<b>Title of Change:</b>	MPL33 Case Outline Lead Length "L" and Lead DAP Length "G" Dimension Tolerance Change
<b>Effective date:</b>	01 Apr 2022
<b>Contact information:</b>	Contact your local onsemi Sales Office or <a href="mailto:Godfrey.Valles@onsemi.com">Godfrey.Valles@onsemi.com</a>
<b>Type of notification:</b>	This Product Bulletin is for notification purposes only. onsemi will proceed with implementation of this change upon publication of this Product Bulletin.
<b>Change Category:</b>	Documentation
<b>Change Sub-Category(s):</b>	Datasheet/Product Doc change

PCN#: PB24618X  
Issue Date: Mar 29, 2022

DOCUMENT NUMBER:	98AON13650G	PAGE 1 OF 1
DESCRIPTION:	WDFN8 3.3x3.3, 0.65P

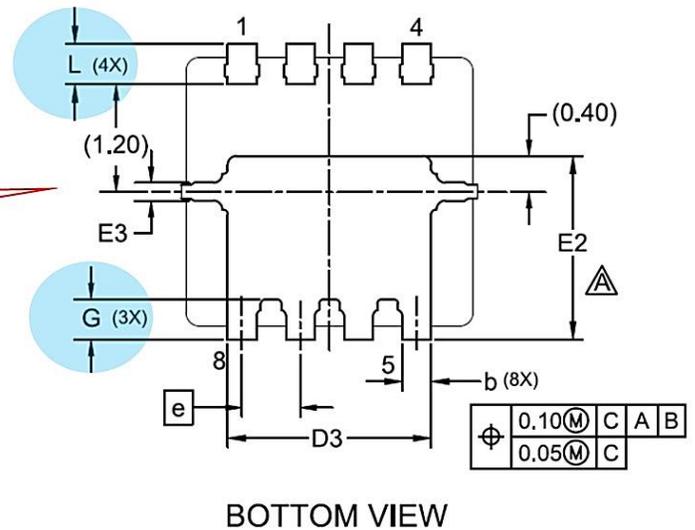
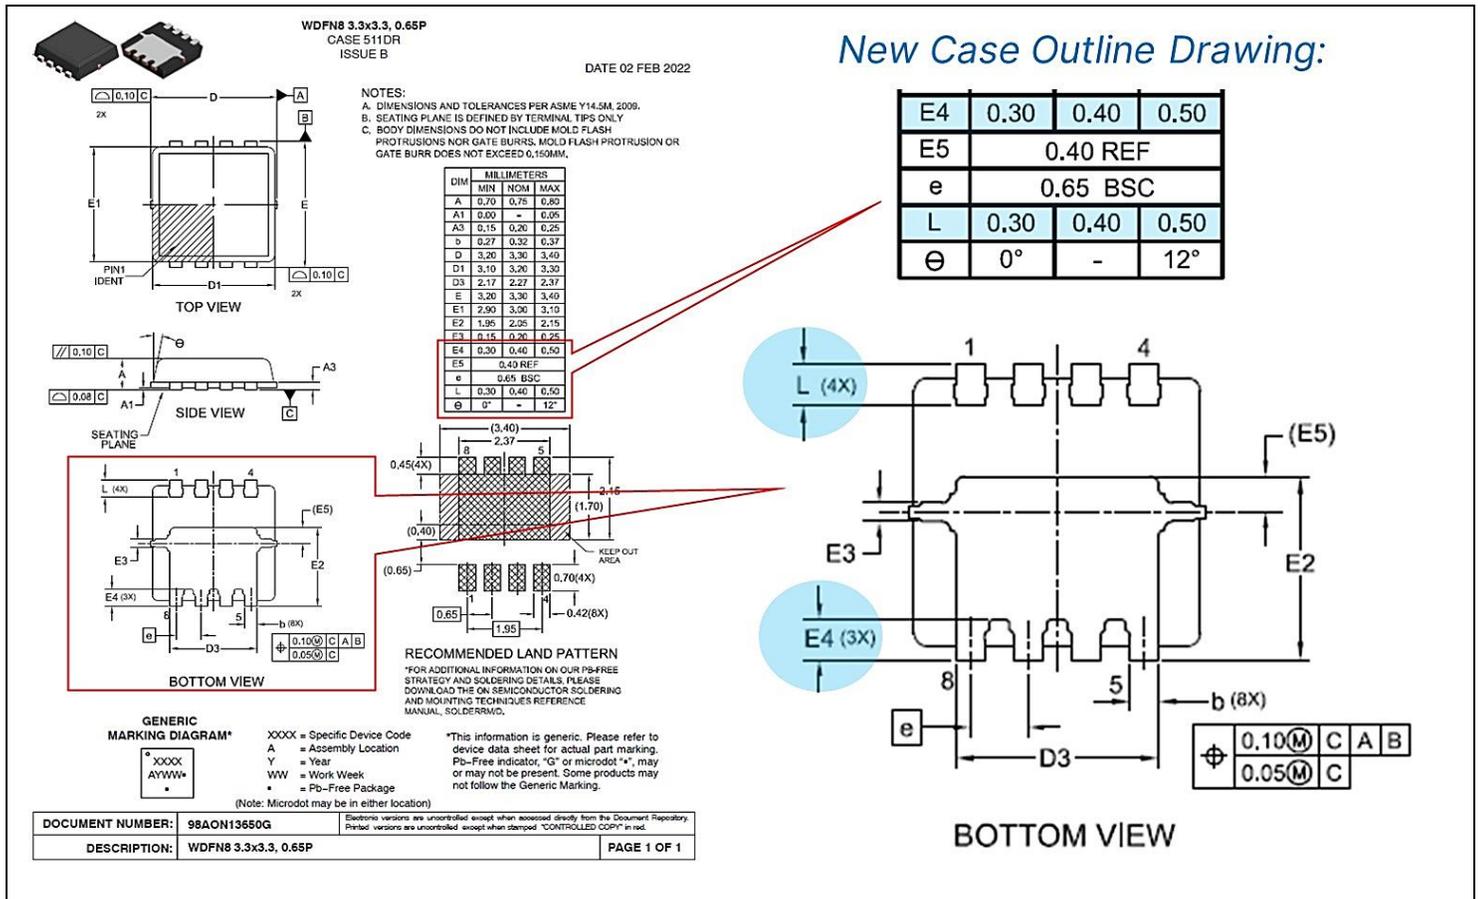
Changed Lead Length (dimension L) and Lead DAP Length (dimension G) to 0.40 +/- 0.10 mm (using JEDEC Standard Tolerance) of 511DR Case Outline. For Reference Case Outline/Dimension Alignment.

E3	0.15	0.20	0.25
e	0.65 BSC		
G	0.40	0.45	0.50
L	0.40	0.45	0.50
Ø	0	-	12
